: SADDLE FITTING, AFT (OUTBOARD/INBOARD)

Process Sheet

DART AEROSPACE LTD	Work Order:	26563
Description: Saddle, Aft Inboard	Part Number:	D2574
Inspection Dwg: D2574 Rev. E		Page 1 of 1

Re: NCR for D2574 saddle

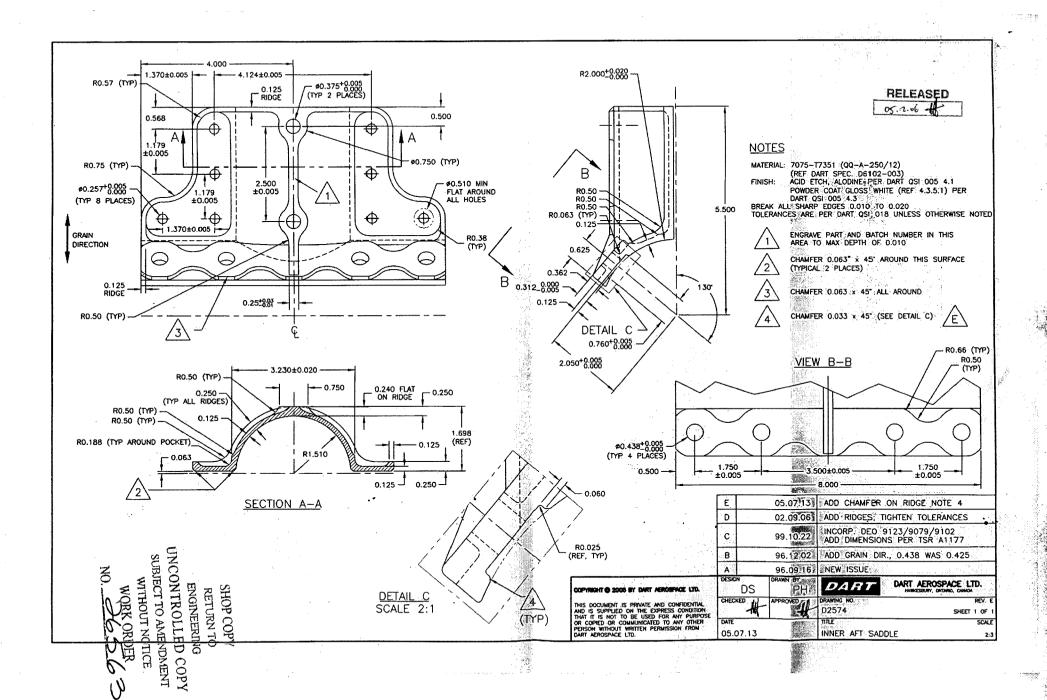
NCR:		W	ORK OR	DER NON-CONFORMANCE	E (NCR)			
DATE	OTER	Description of NC		Corrective Action Section B	Verification	Approval Chief Eng	Approval QC Inspector	
DATE	STEP	Section A	Initial Action Description Chief Eng Chief Eng		Sign & Date			Section C
agarlot	2,3	Dim. "3" 0.125"13 0.106" coffset on 4th Axis roo low. (3rd opp.) (1 proof appliable)	06.04.04	PART OIL per DS enc.1	ED 105/05	66-US-04	Obus.uy Ner	
dolodot	#Z.3	D.m. 'w' a 125' is a 10" offset on 4th Axis to low Coul app First Run	P85 042 06.05.04 QS1042	Paper OK per D& emz.	ED 105/05	60 US-04	06,05,64	06-05-04
,					•			-

```
---- Original Message -----
From: "Chris Provencal" <cprovencal@dartaero.com>
To: <davids@dartaero.com>
Sent: Thursday, May 04, 2006 2:36 PM
Subject: NCR for D2574 saddle
> David,
> Two D2574 Saddles, thickness of saddle wall on skidtube should be 0.125.
On
 one it is 0.110", on another it's 0.106".
                                              Is this acceptable?
> If it were the outside saddle, I would be keen on scrapping it, but
> its the inner saddle, that wall covers such a small area, I'm not sure if
> its that significant?!?
> I attached a picture to show what dimension is affected
> Sincerely,
> Chris Provencal
> DART Aerospace Ltd.
> Email..cprovencal@dartaero.com
> Phone...613-632-3336
> Fax.....613-632-4443
```

For the reasons you have outlined below, I believe these saddles are acceptable.
